Evaluation and Compilation of DOE Waste Package Test Data

Biannual Report: August 1987 - January 1988

U.S. Department of Commerce
National Bureau of Standards

Prepared for
U.S. Nuclear Regulatory
Commission

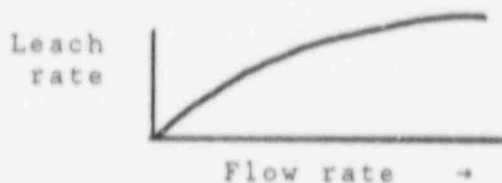
"It is not possible to obtain a general dependence of "durability," on glass composition since leach rates strongly depend on test conditions." "At the present time, extensive data on compositional effects on the durability of glasses are very limited."

"....Attempts at systemization and generalization of compositional effects on glass durability can be fruitful and both experimental and theoretical studies in this area should be pursued."

It must be concluded that the quantitative effects of glass composition on leaching have not been determined. It could be done with a great deal more work. The question is whether this effort will be useful in predicting long-term leach rates. Although nuclear waste glasses would be marginally durable in most commercial glass applications, the "normal" leach conditions in a repository present extremely low reaction rates, regardless of composition.

Ratio of leach
rates; $\frac{\text{DWRG}}{\text{TDS-131}}$

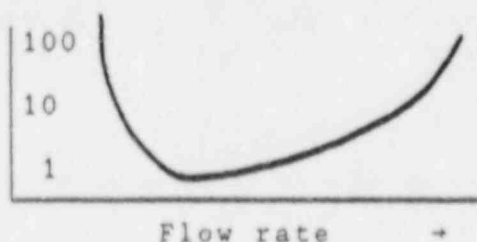
However, the picture is complicated by the fact that those glasses that reach a high equilibrium pH at low flow continue to decompose quite readily at these low flow

rates. A comparison of a relatively resistant glass, DWRG, with a less resistant glass, TDS-131, would indicate the following relative solubility with flow rate.

This highlights a "worst case scenario," where conditions alternate between slow flow and fast flow.
